ADDENDUM No. 1

Building 5170 Renovation – Camp Williams Reference:

DFCM Project No. 08032470

ADDENDUM #1 RENOVATION OF READINESS CENTER BUILDING 5170 CAMP WILLIAMS, UTAH

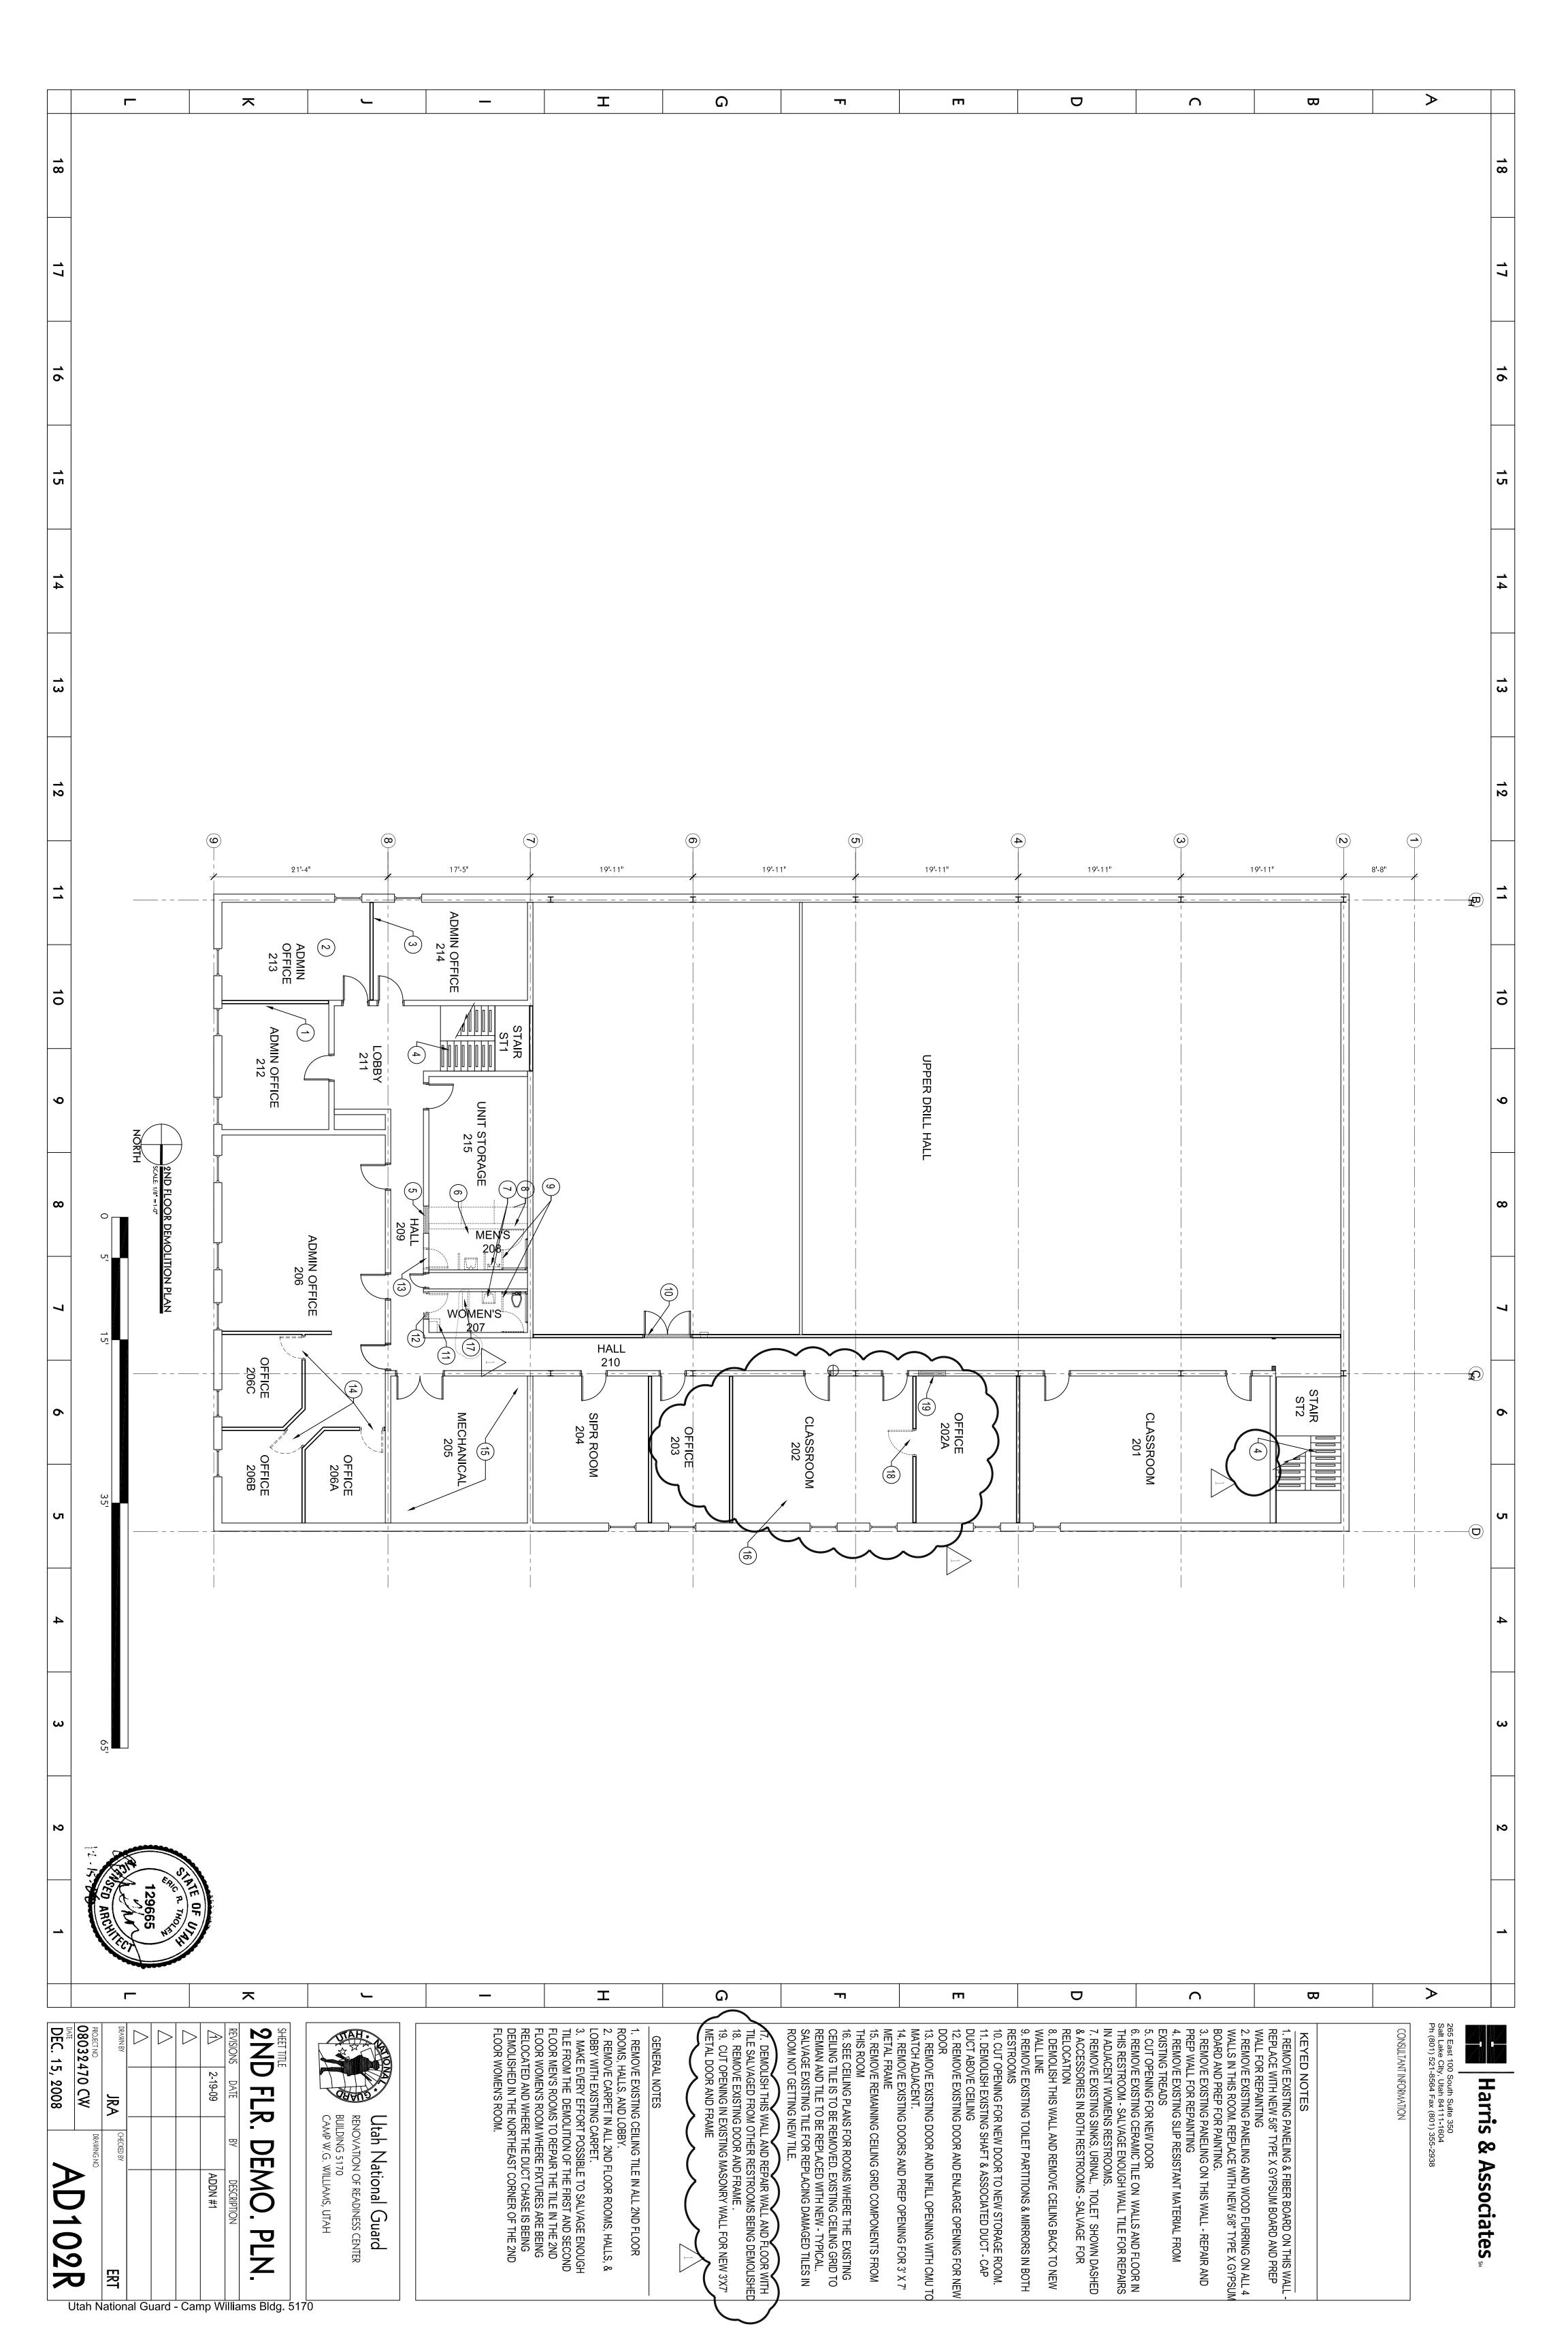
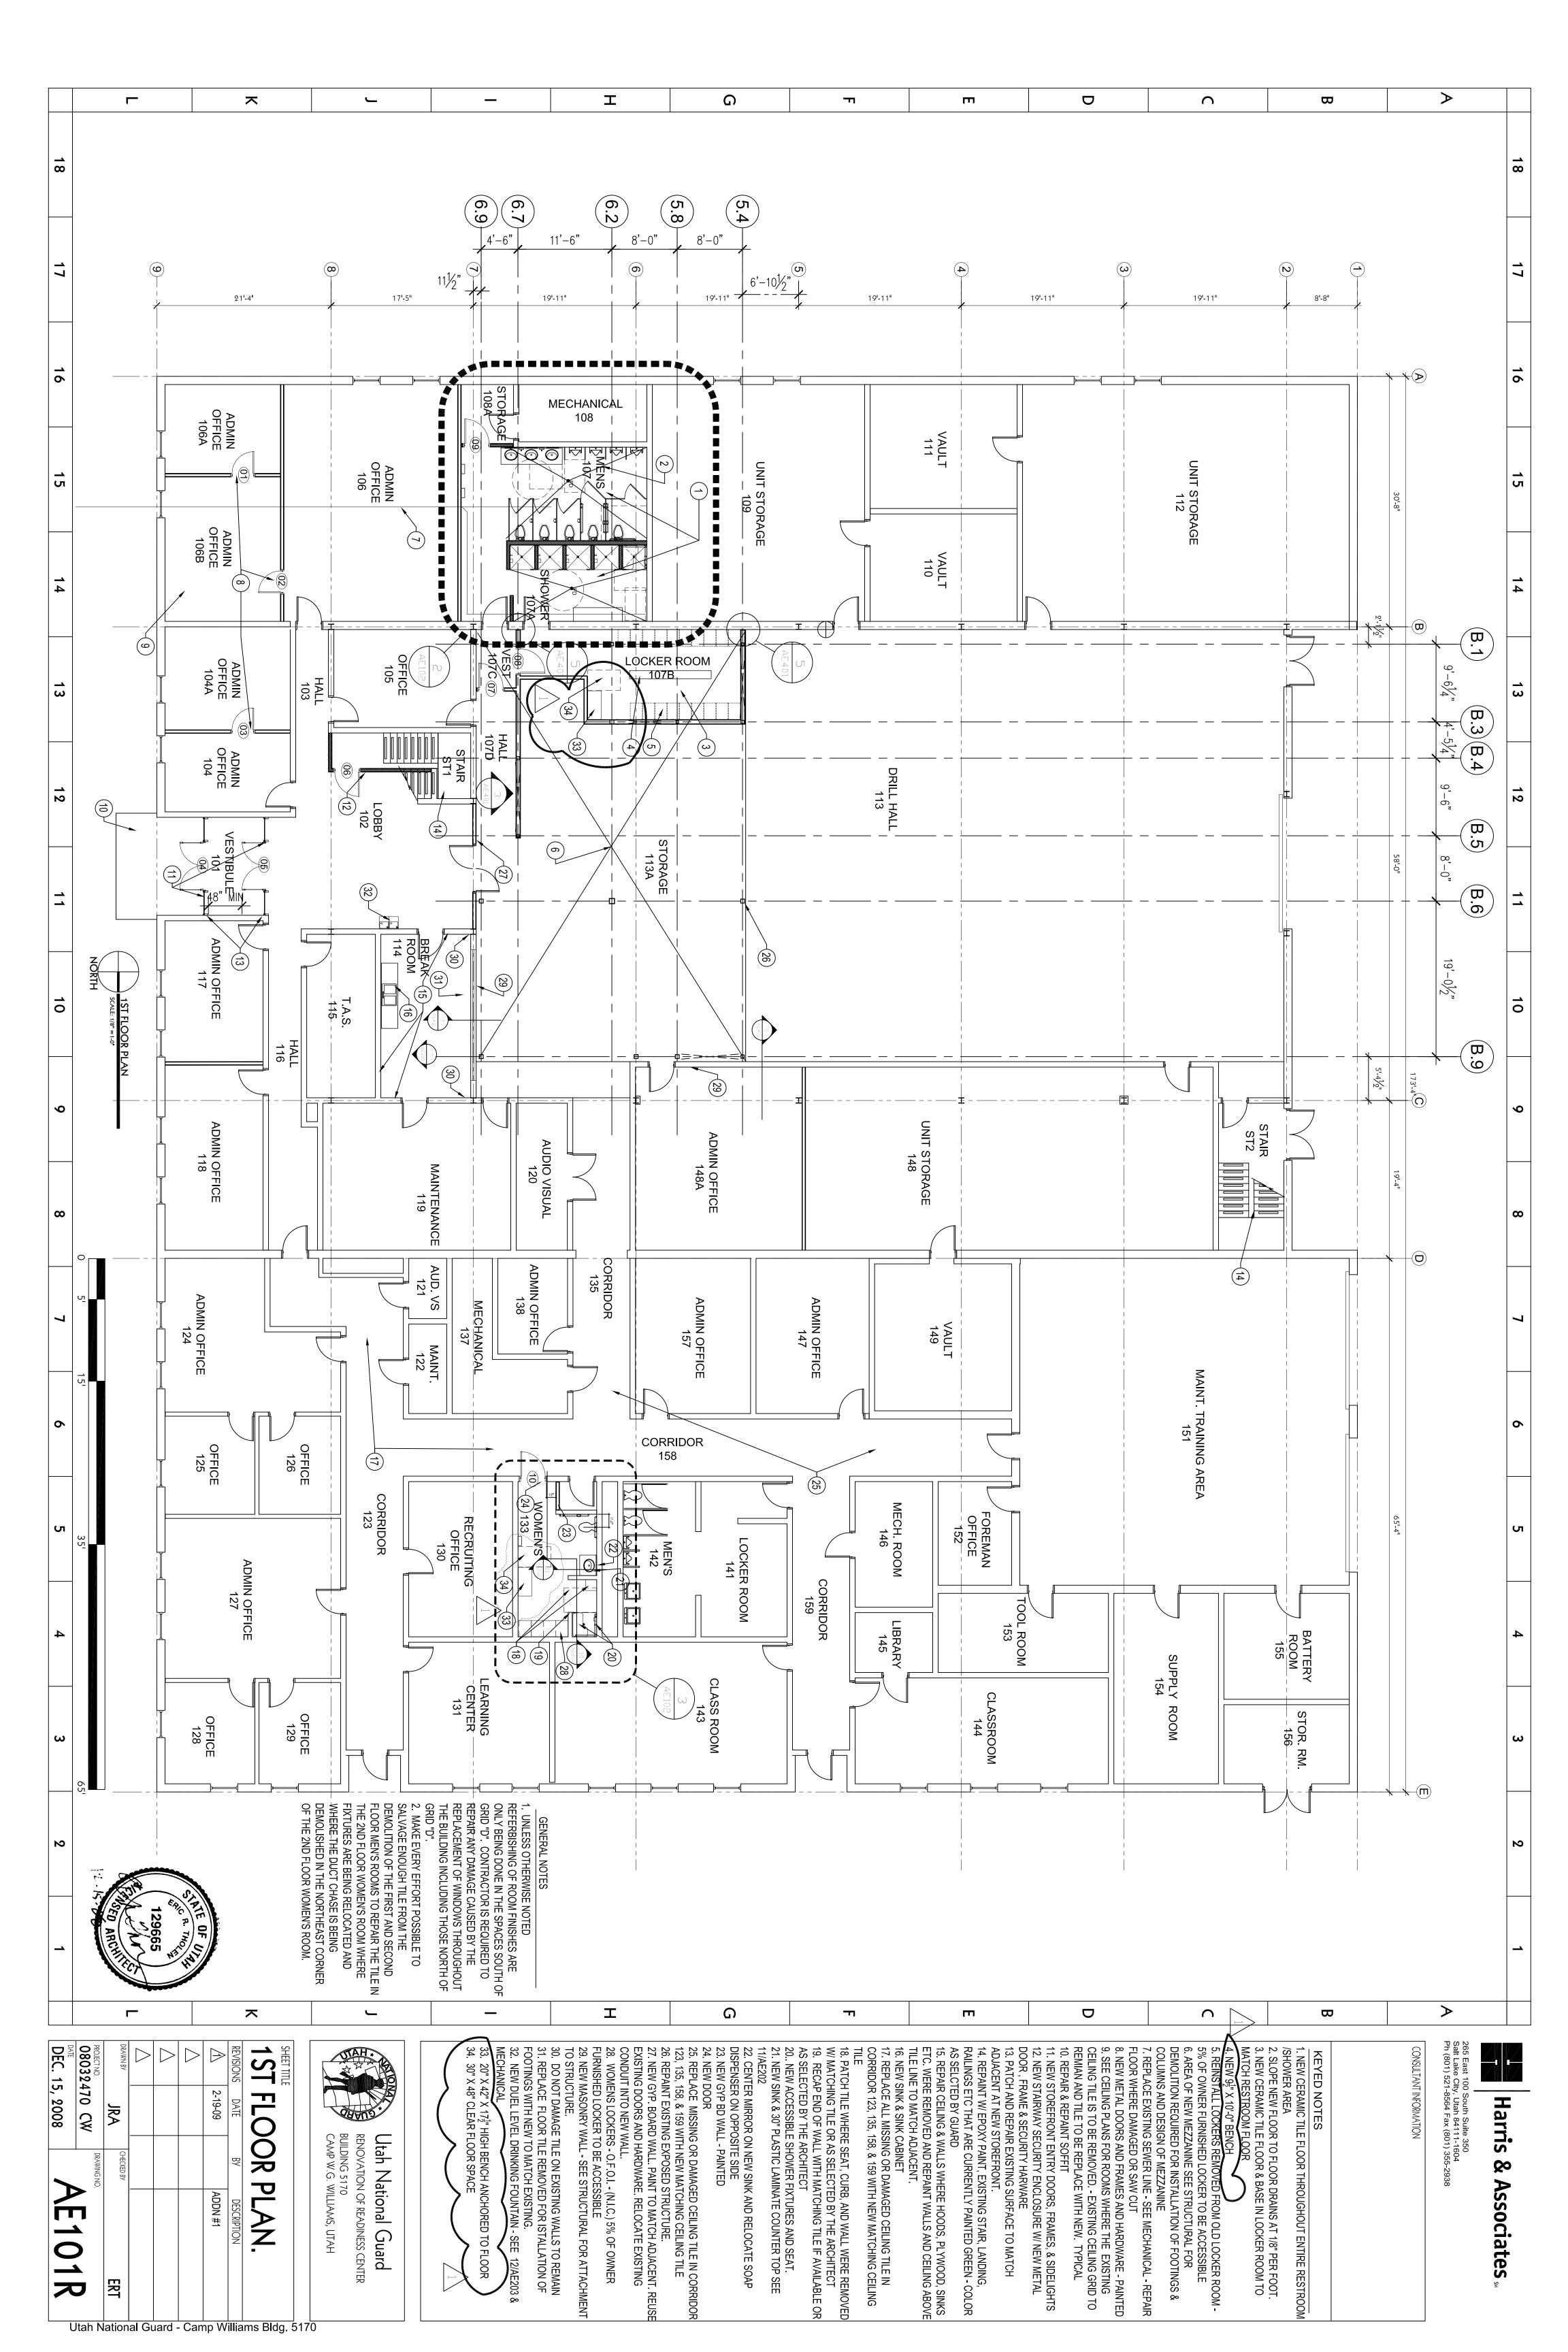
- 1. Assembly Hall 113: Provide 3-each 3-way switches just to the east of the man door at gridline B:2 and 3-each 3-way switches on the wall just east of gridline of C:5. Each set of 3-way switches will control 1 row (1 circuit) of the high bay fluorescent light fixtures.

- 2. The "Cable Tray" shown on sheets EP101 and EP102 is 12 inch wide basket tray, and is not ladder type cable tray as indicated in the specifications.

- 3. Add a 4-inch conduit stub from the primary side of the new pad mounted transformer. Extend the conduit stub, out a minimum of 5-feet beyond the concrete pad, to the east. Provide a cap and label on the spare stub out conduit for the future connection to pad-mounted switch.

- 4. HF-99 fixtures shall be from the same family and have the same performance but shall be grid mounting type or provided with flange kit for mounting in grid ceiling.

- 5. The wall between Classroom 202 and Classroom 203 has been removed and there are two power outlets stubbed above the floor. Contractor shall remove and relocate outlets to 2 separate adjacent walls in the new room. Coordinate with Utah National Guard staff for desired location of outlets.

- 6. Prior approved equals
 - a. HF-99: the equivalent fixture in Columbia Lighting is considered to be equal.
